NOTICE OF DECISION
C.S. Lewis Academy – New Modular Building
Site Design Review – DR223-0002/ADJC23-0004 – 1605 N College Street

C.S. Lewis Academy – New Modular Building Site Design Review – DR223-0002/ADJC 23-0004 – 1605 N College Street

FILE NO: DR223-0002
REQUEST: Install a 1,792 square foot modular classroom at an existing school
LOCATION: 1605 N College Street
TAX LOT: R3218AD 06900
R3218AD 07000
R3218AD 07100
APPLICANT: Daniel Danicic, PE (Yamhill Land Services, LLC)
OWNER: Pacific Region Open Bible Standard Churches
ZONE: R-1 (Low Density Residential)
SUBDISTRICTS: Airport Overlay Subdistrict

Accessibility Route

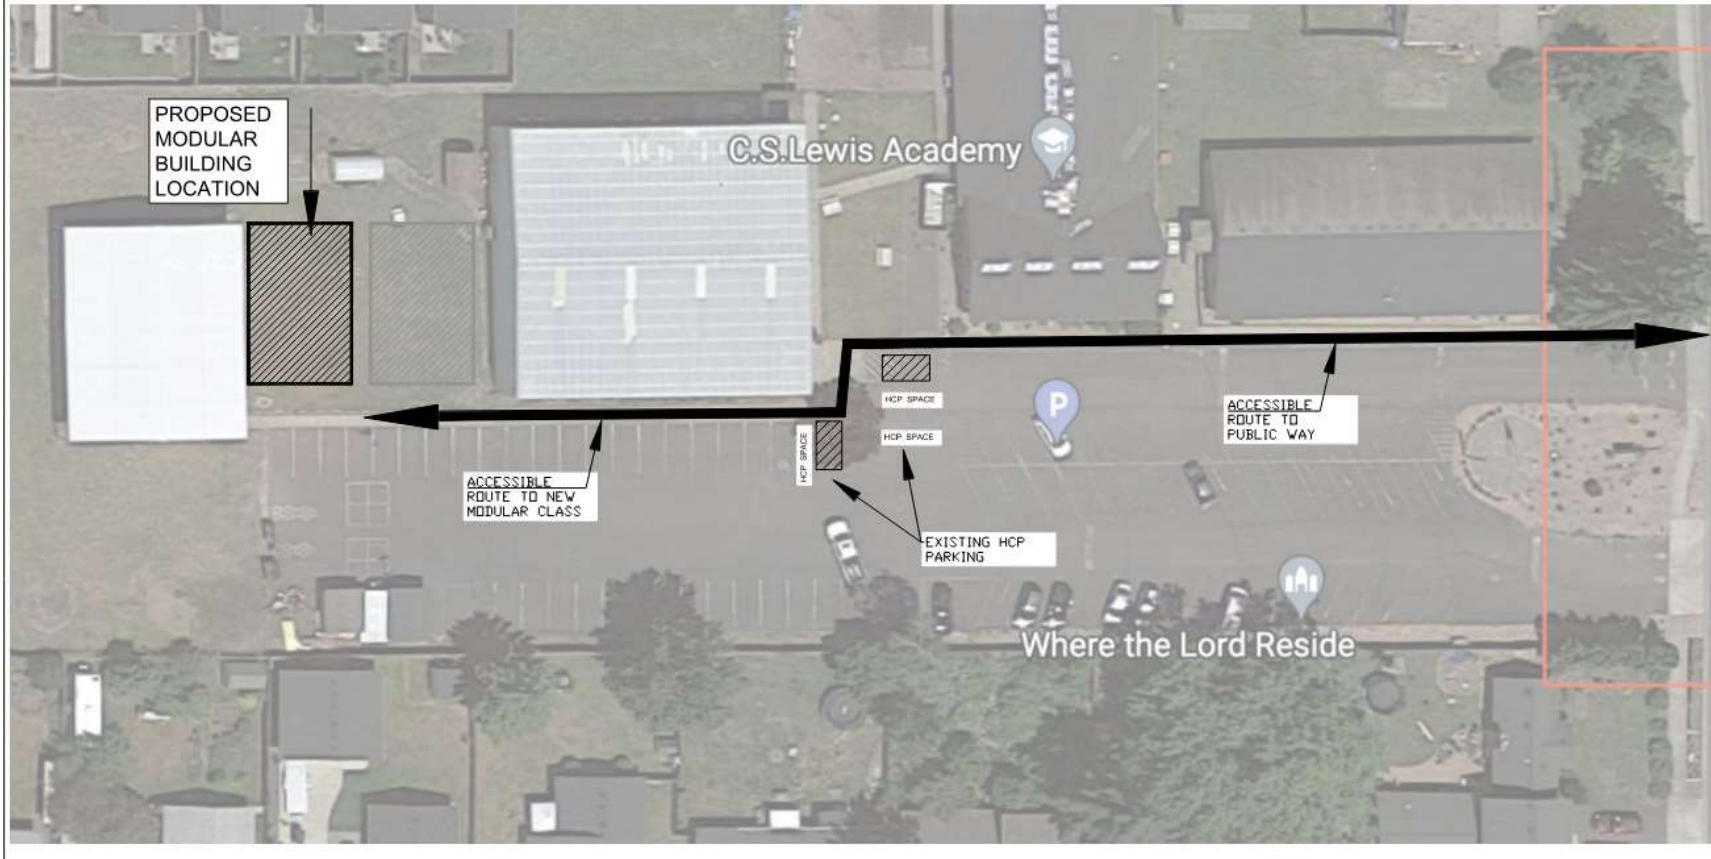
Because the application materials do not depict or describe how the existing private pedestrian pathway will provide a connection to the modular classroom's access ramp which is compliant with the Americans with Disabilities Act Requirements, the Applicant shall be required to provide a connection that meets the applicable building code and Americans with Disabilities Act requirements for access from the existing pedestrian pathway to the proposed modular classroom during the building permit process and prior to occupancy.

1. **ADA Accessible Connection to Pedestrian Pathway:** The Applicant shall be required to provide a connection that meets the applicable building code and Americans with Disabilities Act requirements for access from the existing pedestrian pathway to the proposed modular classroom during the building permit process and prior to occupancy.
